Re: Utility PURPA Compliance Filings –  
Comments on Utility Avoided Cost Prices for Consideration in Advance of the  
November 22, 2019 Open Meeting

Docket Nos. UE-190663 – Avista  
UE-190665 – Puget Sound Energy  
UE-190666 – PacifiCorp

Figure 1

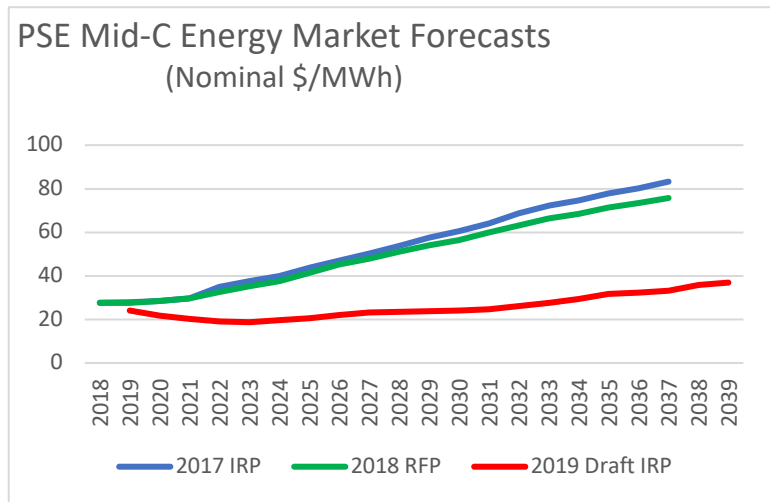
PSE’s Mid-C market forecast departs dramatically from its current draft 2019 IRP forecast. This forecast is far lower than either PSE’s 2017 IRP market forecast or even the forecast used to estimate avoided costs for its 2018 all source RFP. See Figure 1.<sup>12</sup> While PSE incorporates recent developments in the market, such as the expected social cost of carbon and implementation of Washington’s Clean Energy Transformation Act (“CETA”), the stark difference in this forecast from its prior forecasts and even from current Mid-C market prices, warrants a well-reasoned explanation for the departure. PSE asserts that the Commission’s rules, by allowing utilities to use their current market forecasts, “do not require that estimated avoided costs of energy come from a source where the forecast accuracy must be vetted.”<sup>13</sup> While the

most up-to-date forecast may appear on its face to be beneficial to ratepayers, it is not beneficial where it is not accurate. Accuracy should be a primary goal of setting PURPA avoided cost prices because inaccurate pricing will harm ratepayers, whether over- or under-estimated. An overly high forecast may harm ratepayers by sending price signals to QFs that are too

market and the utilities’ respective ratepayers. As such, the Commission should require PSE and Avista to each revise their compliance filings using appropriate market forecasts, either from their most recently acknowledged IRP or recent RFP schedule of avoided cost.

Figure 2

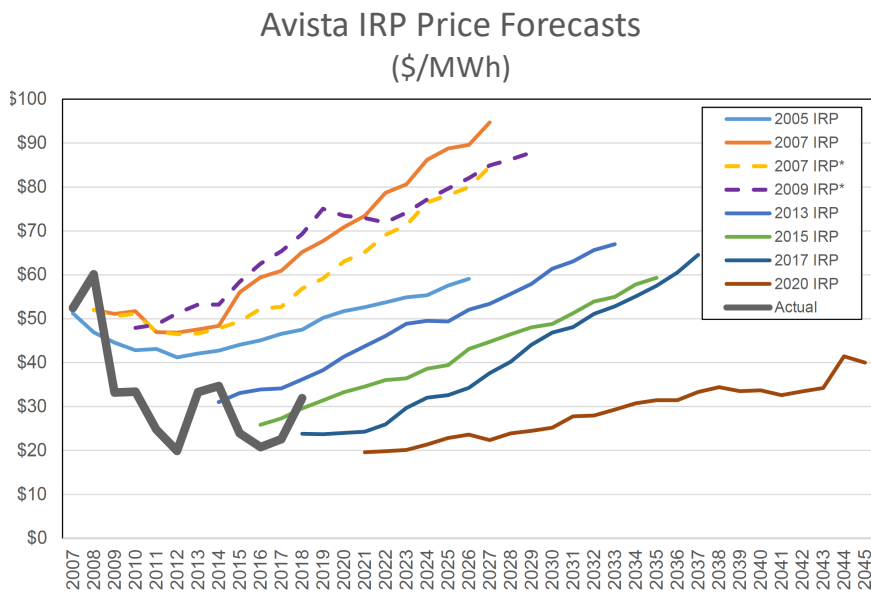
Avista's Mid-C market forecast from its current draft 2020 IRP is similarly questionable. This forecast is far lower than any of Avista's recent forecasts. *See* Figure 2.<sup>14</sup> Even the actual prices in 2013, 2014 and 2018 appear to be higher than the 2020 IRP forecast through 2043.

In reviewing the underlying assumptions of PSE's and Avista's market forecasts, nothing stands out as the obvious explanation for this dramatic shift in pricing. PSE and Avista's filings lack any discussion for why such a substantive departure exists. The main suspect of a lower price forecast is natural gas prices, but those have generally remained consistent in recent years,<sup>15</sup> and without the opportunity to dive into the modeling, there is little ability to vet these inputs. It is unclear, for example, the extent to which each utility considered supply resource adequacy such as the effect on market prices of the expected retirement of 3,600 MW of coal generation.<sup>16</sup>

Figure 3

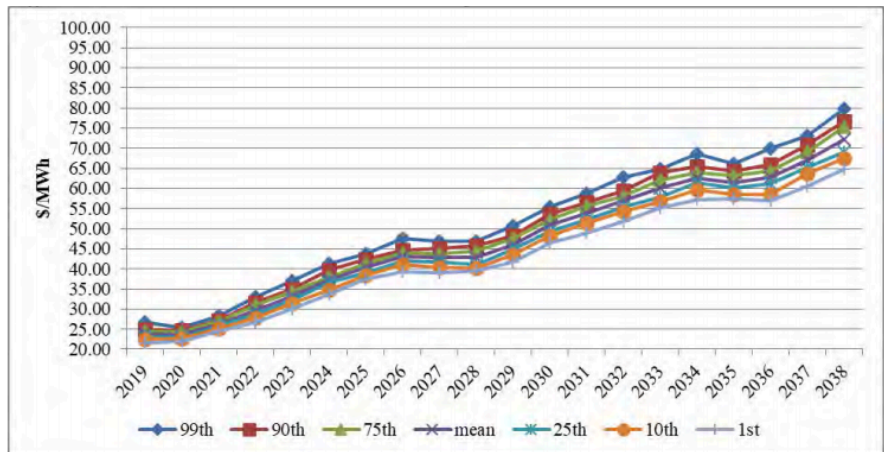
Further, PacifiCorp produced a significantly higher price forecast in its avoided cost filing, and even in its recently released IRP. *See* Figure 3.<sup>17</sup> Notably, PacifiCorp's avoided cost filing uses a forecast that projects a minimum of a \$61.56/MWh price in 2038<sup>18</sup> and its recent IRP simulation projects that 2038 Mid-C prices will range somewhere between \$65.00/MWh at the first percentile to \$80.00/MWh at the 99th percentile.<sup>19</sup> In contrast, PSE projects a price of \$35.93 in 2038 and Avista projects \$38.60/MWh in 2038. Avista and PSE's earlier market price forecasts are more in line with PacifiCorp's price forecasts than their current forecasts.
